AMENDMENTS TO THE DRAWINGS

REMARKS

FIG. 4

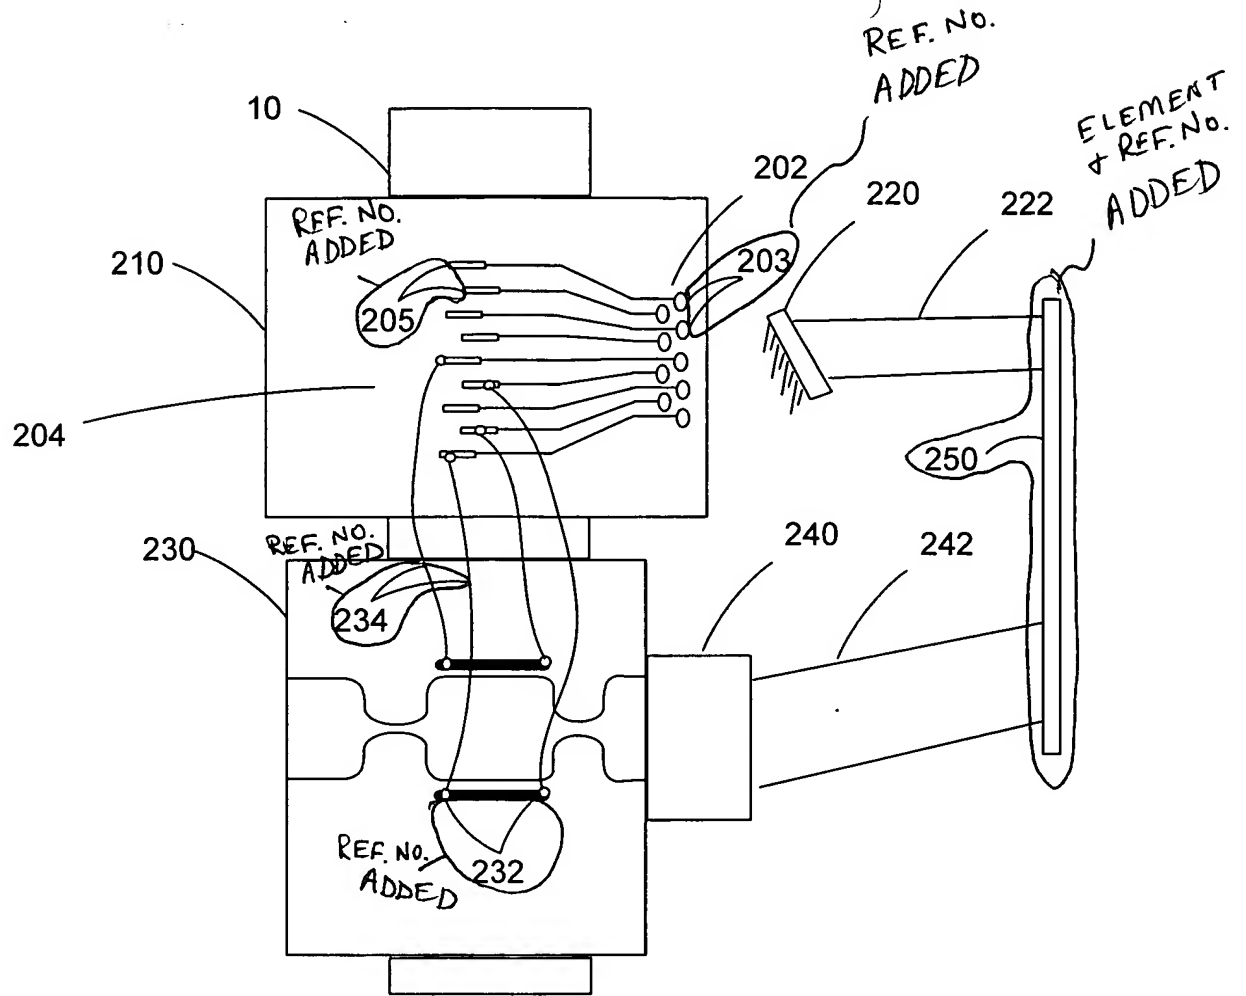
(2) The Examiner objected to the drawings under 37 CFR 1.83(a) for failing to show a tester. FIG. 4 has been amended to show tester 250 and the paragraph beginning on page 6, line 7 of the specification has been amended to introduce the reference number 250 for the previously mentioned tester. Therefore the objection is believed to be moot.

(3) The Examiner objected to the drawings because multiple holes on PCB 210 for connector 220 requires a reference numeral. FIG. 4 has been amended to label the holes with reference numeral 203 and the paragraph beginning on page 6, line 7 of the specification has been amended to introduce the reference number 203 for the previously mentioned holes. Therefore the objection is believed to be moot.

(4) The Examiner objected to the drawings because multiple electrical pads of second interface 204 requires a reference numeral. FIG. 4 has been amended to label the electrical pads with reference numeral 205 and the paragraph beginning on page 6, line 11 of the specification has been amended to introduce the reference number 205 for the previously mentioned electrical pads. Therefore the objection is believed to be moot.

(5) The Examiner objected to the drawings because various nodes on PLC requires a reference numeral. FIG. 4 has been amended to label the nodes with reference numeral 232 and the paragraph beginning on page 6, line 11 of the specification has been amended to introduce the reference number 232 for the previously mentioned nodes. Therefore the objection is believed to be moot.

(6) The Examiner objected to the drawings because wire bonding between 210 and 230 requires a reference numeral. FIG. 4 has been amended to label the illustrated wirebonding with reference numeral 234 and the paragraph beginning on page 6, line 11 of the specification has been amended to introduce the reference number 234 for the previously mentioned wirebonding. Therefore the objection is believed to be moot.

(7) The Examiner objected to the drawings because the soldering wires of claim 3 are allegedly not shown. Applicants respectfully disagree. The wires were shown in FIG. 4 and have now been labeled wirebonds 234. Therefore the objection is believed to be moot.
